A new dust seal has been introduced to help prolong the life of the accessory drive oil seal. The outer lip of the new dust seal has been increased by 0.050 inches to allow the seal to be pressed flush with the pulley face. This provides the correct clearance between the dust seal and main oil seal.

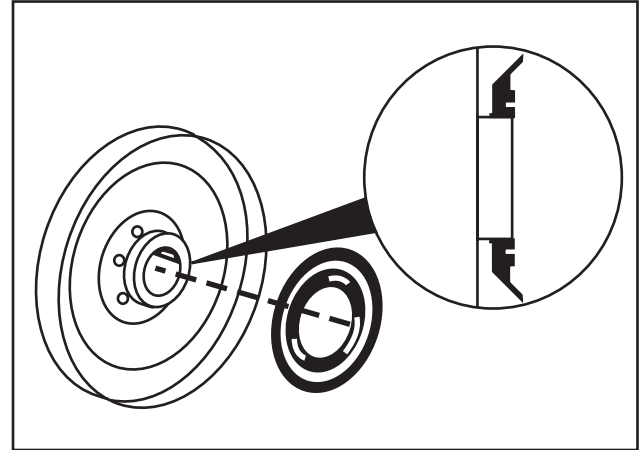
Un nuevo diseño de guardapolvo ha sido introducido en el mercado, que prolonga la duración del servicio del sello de aceite para Mando el Accesorios. El reborde externo del nuevo guardapolvo se ha aumentado .050 centésimas de pulgada para permitir que el sello pueda ser prensado a ras con la cara de la polea. Esto proporciona la separación correcta entre el guardapolvo y el sello de aceite principal.

1. Place a light film of oil or soapy water on the inside circumference of the dust seal.
2. Install the dust seal on the pulley hub so the larger diameter side of the seal is facing away from the pulley.
3. Press the dust seal onto the hub until the inside diameter of the seal is flush with the face of the pulley hub.

1. Aplique una ligera capa de aceite o agua jabonosa a la circunferencia interior del guardapolvo.
2. Instale el guardapolvo en el borde de la polea de tal manera que el lado del diámetro grande quede en dirección opuesta a la cara de la polea.
3. Preense el guardapolvo sobre el cubo hasta que el diámetro interior del sello este a ras con la cara del cubo de la polea.
